# SAFETY RECALL BULLETIN

**AUTOCAR SAFETY RECALL A-1002**  
**NHTSA RECALL 10V-046**

ACX Steering Gear Bracket

**Figure 8**

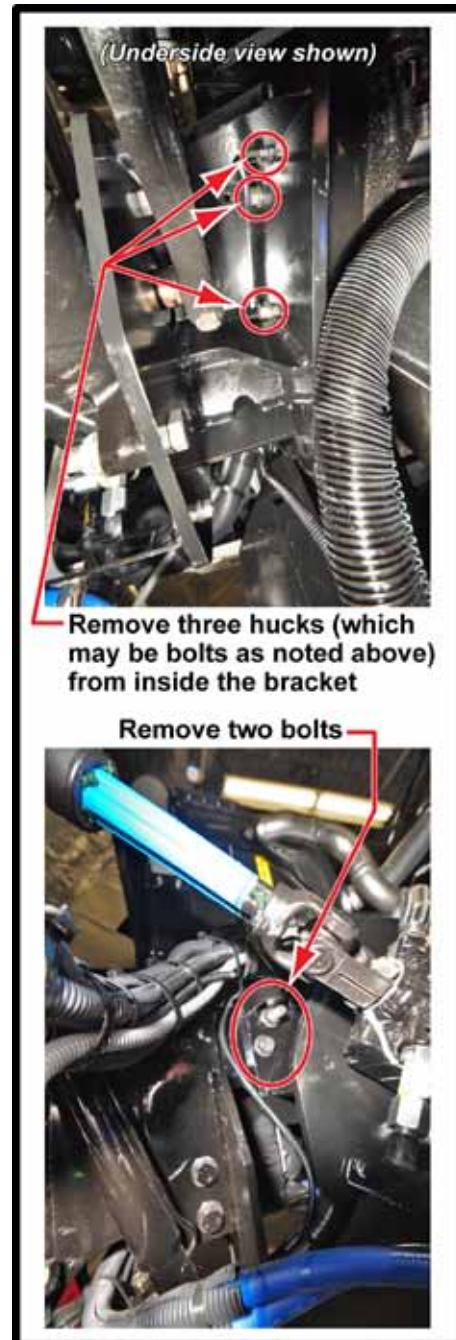
9. Remove the steering gear bracket by removing the the three hucks and two bolts that hold the steering gear box to the frame (see Figure 8). Also remove the "Z" bracket which is retained by one of the above-mentioned bolts (see Figure 7).

10. Install the new steering gear bracket using the following parts:  
S3831001K001, SVC KIT, ACX LHD STRG GEAR BRKT-  
From S3831001K002, SVC KIT, HDW, ACX LHD STRG GEAR -

(4) 8397080 FLANGE SCREW 5/8"-11 X 2 1/2"  
(1) 8397082 FLANGE SCREW 5/8"-11 X 3"  
(5) 8307202 FLANGE LOCK NUT 5/8"-11  
Also reinstall the "Z" bracket that was removed in *step 9*.  
See Torque Specifications on *page 2*.

**Figure 7**

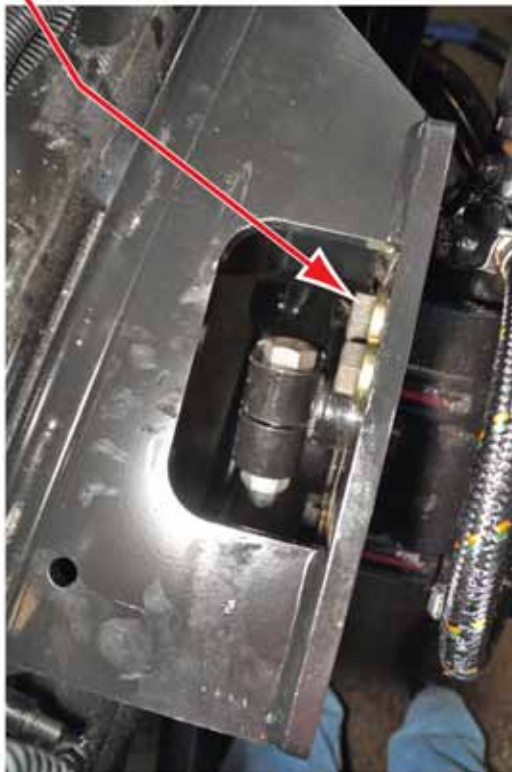
8. Remove the steering gear box by first removing the “L” bracket that is attached to the steering gear bracket, then remove five bolts that hold the steering gear box to the bracket (see *Figure 7*).

Remove five bolts from inside bracket  
(all bolts not seen in this view)

**Figure 9**

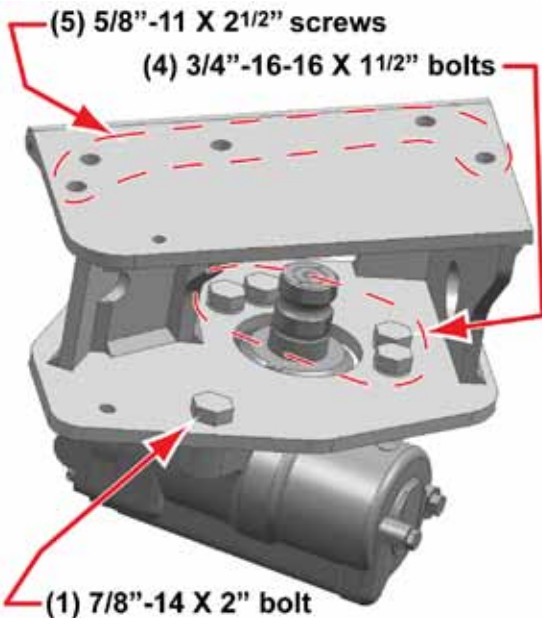
10. Install the new steering gear bracket using the following parts (see *Figure 9*):  
**S3831002K001, SVC KIT, ACX RHD STRG GEAR BRKT**

From S3831002K002, SVC KIT, HDW, ACX RHD STRG GEAR -

(5) 8397080 FLANGE SCREW, 5/8"-11 X 2 1/2"

(5) 8397202 FLANGE LOCK NUT, 5/8"-11

11. Reinstall the steering gear box to the new bracket using the following new hardware (see *Figure 9*):

(4) 99-9431009 HEX BOLT, 3/4"-16 X 1.5"

(4) 3082677 SPACER WASHER 3/4" X 1/8"

(1) 99-9431009 BOLT, 7/8"-14 X 2"
